Corrigendum to “Integrated Life-cycle Assessment of Electricity Sources”, UNECE

Thomas Gibon, 05.07.2022

Summary

Figure 1. Lifecycle land use regional variations for year 2020. Variability is explained by several factors: electricity mix (all regions), origin of supply (fossil fuels), load factors (renewables). Nuclear power is modelled as a global average and therefore does not see any variation.

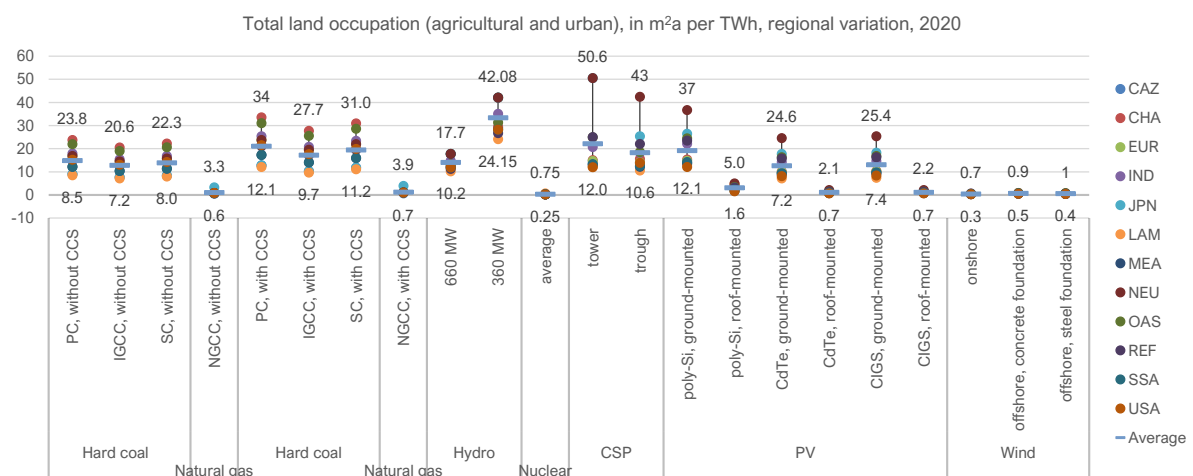
In June 2022, a reader found that the land use value (in m²a) for some technologies suspiciously high and informed the authors. A few days later a modelling error was found regarding the inclusion of biomass in background electricity mixes, which artificially increased land use for energy-intensive processes. This happens to be relatively important for silicon photovoltaics, and this effect was exacerbated in regions with comparatively low solar irradiance, such as Japan. The error was corrected (see details in the next section) and the following land use figure created. Figure 1 replaces Figure 57 (page 78) in the UNECE report.

Figure 2. Flow of "agricultural land use" in the roof-mounted polycrystalline silicon PV model for the Japan region, 60% was originating from the use of biomass in the background electricity mix (for a share in the mix of <5%).

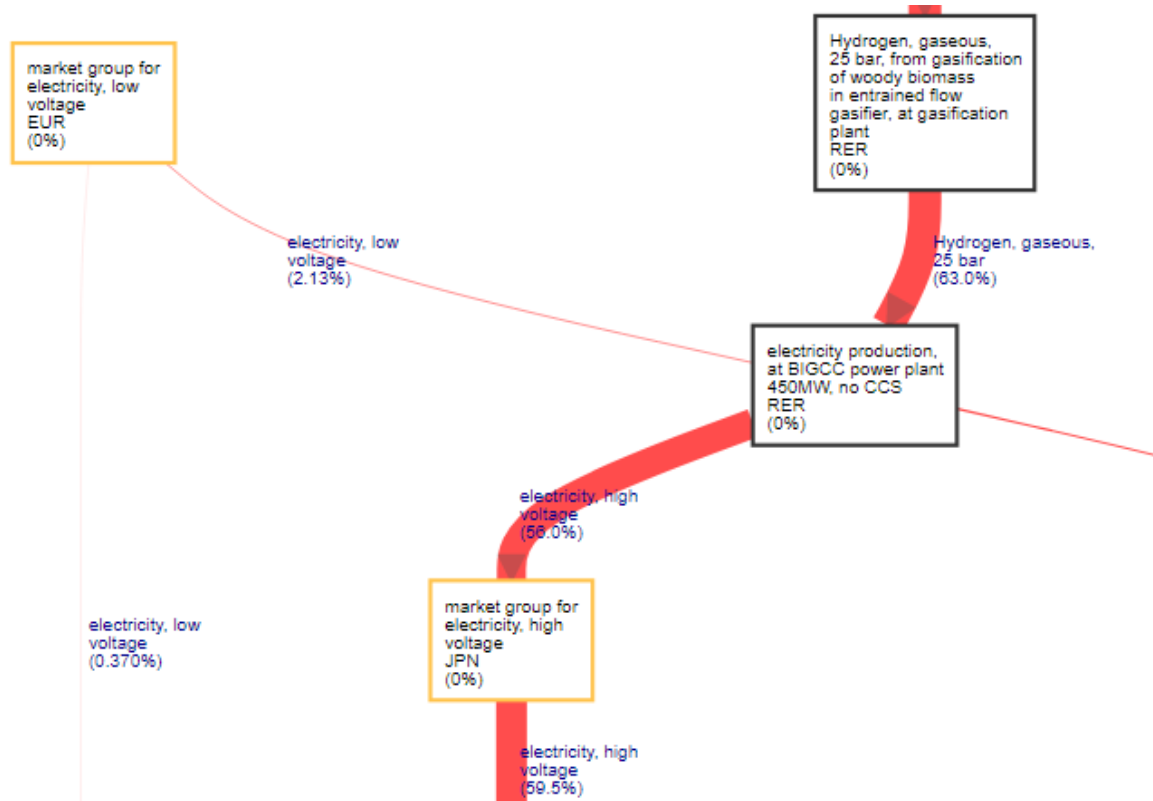
In 2020, some regions use non-negligible shares of biopower, which was approximated with electricity from a typical BIGCC² power plant. The technological description for this technology was extracted from Volkart et al. (2013) [2], as available in a very early version of *premise*. Using this inventory led to very high agricultural land use, as illustrated in Figure 2. This was corrected in the latest version of *premise*, where this dataset was replaced, adapting the data from Briones-Hidrovo et al. (2021) instead [3]. This update corrected the land use value.
